**Planning Commission Meeting Agenda**

Tuesday, October 16, 2018, 5:30 PM

1. Gallagher Residence Remodel and Addition (CL) 114 S. Harris St.; PL-2018-0411 22

## Planning Commission Staff Report

# PROPOSED SITE PLAN

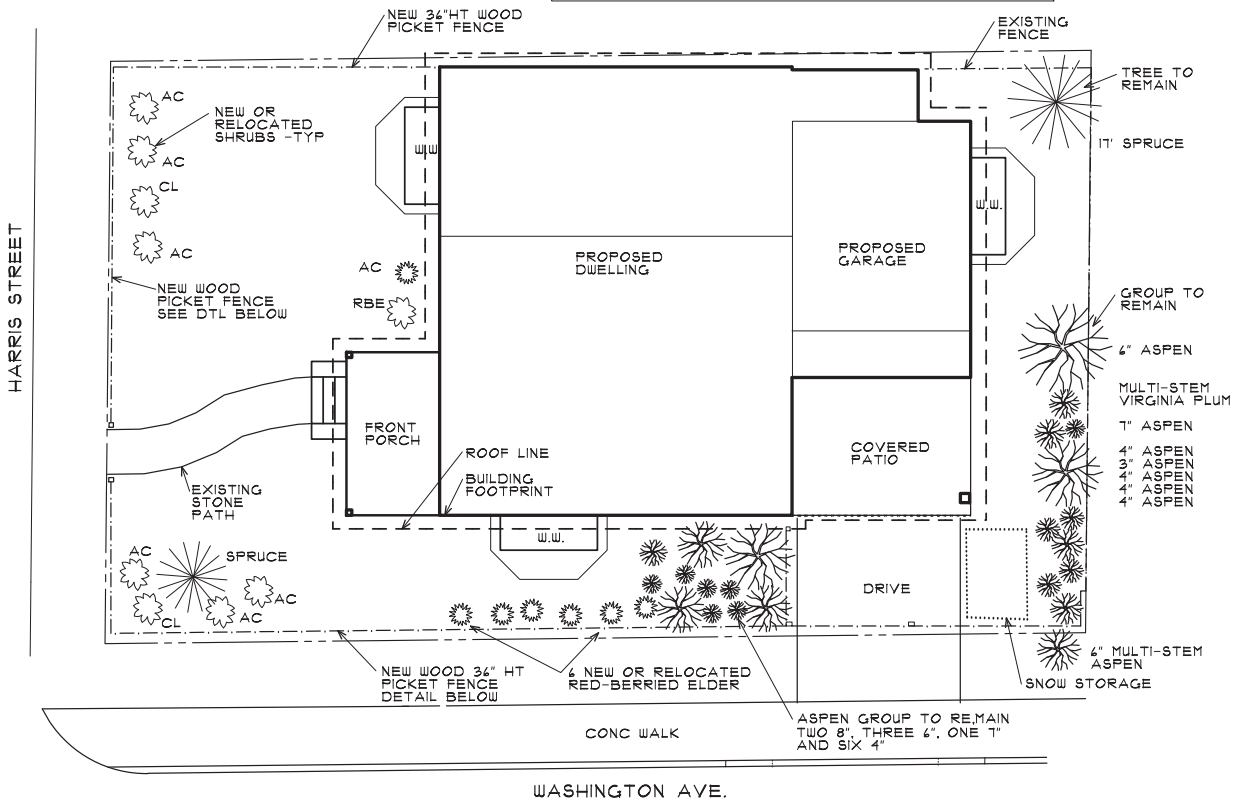
**Snow Removal and Storage (Policy 13R and 13/R):** The applicant has designated 39.5 sq. ft. of snow storage area, which exceeds the 25% encouraged by this policy. Staff has added a Condition of Approval that snow storage be designated on the site plan for the front stone walkway.

10. **Snow storage area shall be designated on the final plans for the stone walkway in the front yard, and the site coverage calculations updated accordingly.**

# PROPOSED LANDSCAPE PLAN

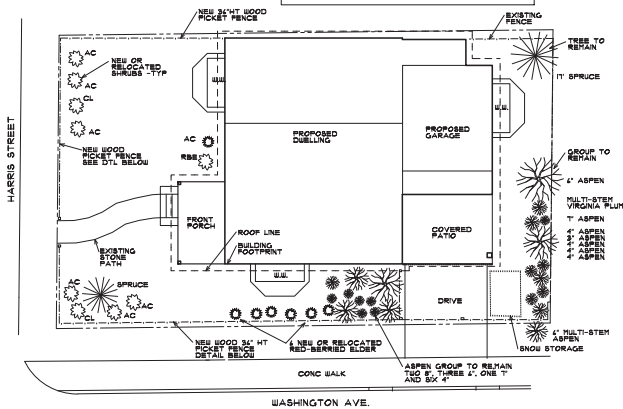
**Landscaping (Policy 22/A and 22/R):** There is an existing 17’ tall Spruce on the lot, eight (8) Aspens along the eastern lot boundary (3” to 7” caliper), twelve (12) Aspens along the southern lot boundary (4” to 8” caliper), for a total of 21 existing trees on the lot, in addition to several shrubs. The applicant proposes an additional 6’ tall Spruce, and 11 shrubs. Staff appreciates the additional landscaping in the front yard and side yards, finding that it will provide buffer and screening along the right-of-way. A Condition of Approval has been added that the right-of-way adjacent to the property be re-vegetated.

- Design Standard 131: At staff's request, the applicant has added an evergreen tree in the front yard, as is recommended by this Standard.
- Design Standard 132: This Standard encourages the planting of cottonwood trees along street edges, in order to reinforce the alignment of street trees along property lines. Staff has added a Condition of Approval that a Cottonwood tree be added in the front yard along Harris St.

11. **The final plans shall specify the proposed fence to be painted.**
12. **The final plans shall specify a Cottonwood tree of a minimum 2" in caliper be planted in the front yard along Harris St.**

**WEST ELEVATION**

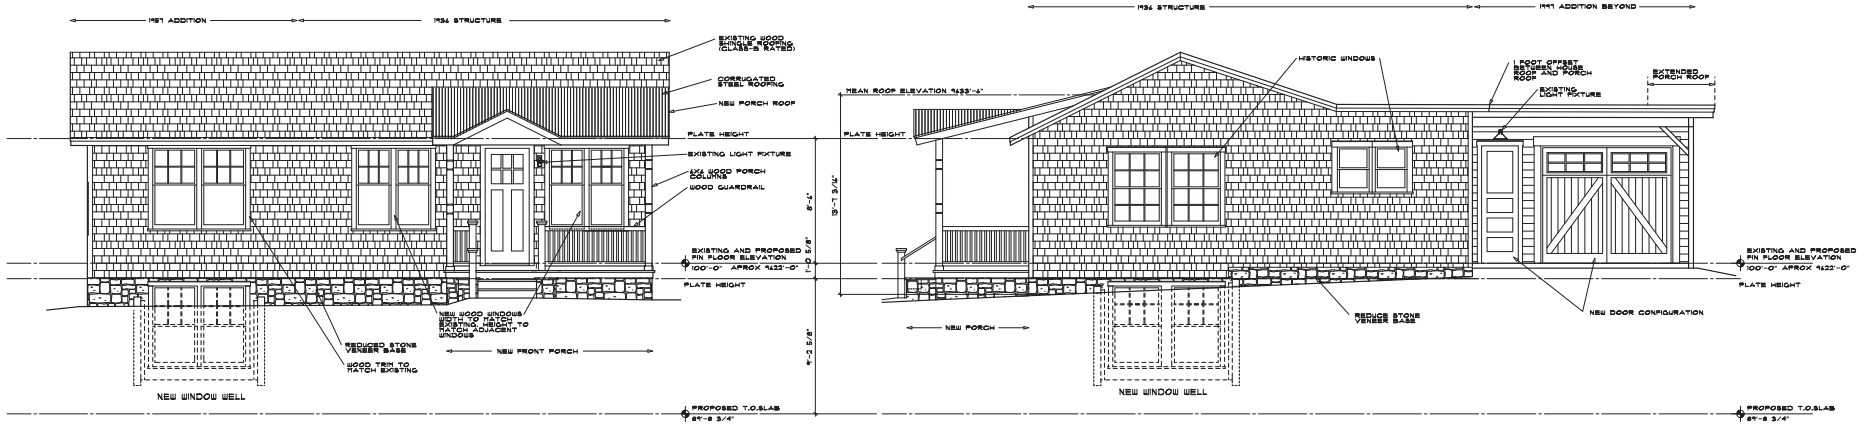
- Priority Design Standard 77: *"Maintain original window proportions...do not...enlarge the original opening to accommodate...larger windows."* The applicant proposes to modify the two existing window openings on the west façade on either side of the front door, in order to install new taller, vertically oriented windows that will match the height of the other existing window on the west façade. Although staff does not have access to any historic photograph showing the original windows, staff supports the more historically accurate, vertically oriented windows. Staff has added a Condition of Approval that that applicant shall demonstrate to staff during the construction process that the historic window openings are being maintained, in order to ensure historic fabric
